# SERVICE BULLETIN 125

## INFORMATIONAL ADDENDUM

**SUBJECT:** ADDENDUM - Service Bulletin 125 has been amended.

**HM/HMSK80-110**

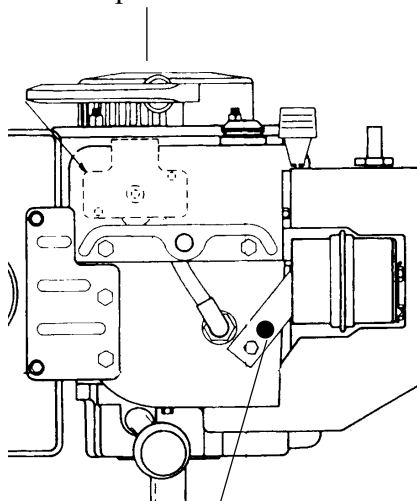
STAMP "0" ON MUFFLER STRAP

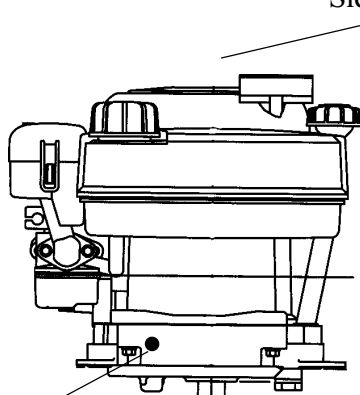
STAMP "0" ON FLANGE

**LEV115**

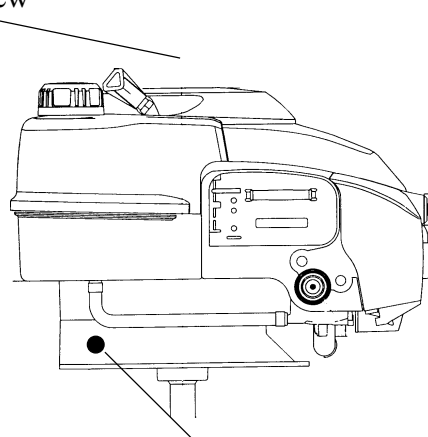
STAMP "0" ON FLANGE

**H/HS/HSSK35-70**

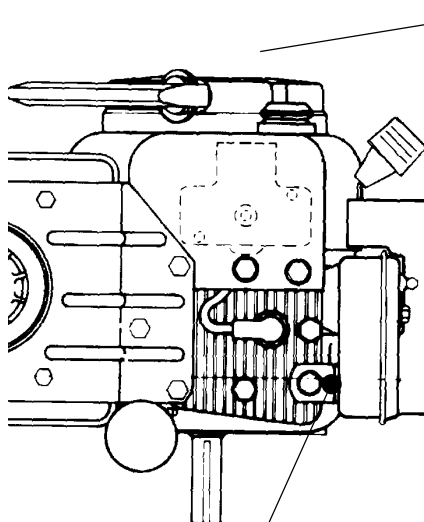
STAMP "0" ON MUFFLER STRAP

**OHSK80-130**

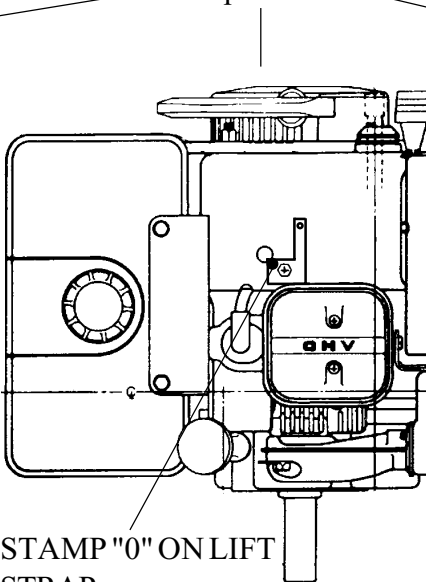
STAMP "0" ON LIFT STRAP

**OHSK50-70**

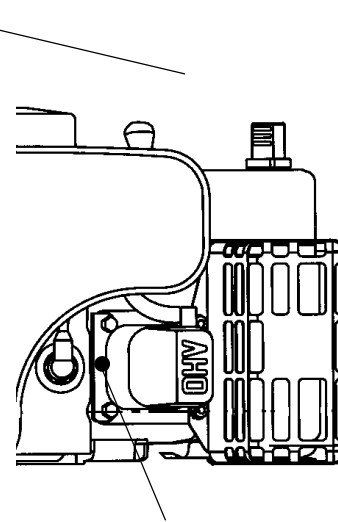
STAMP "0" ON LIFT STRAP
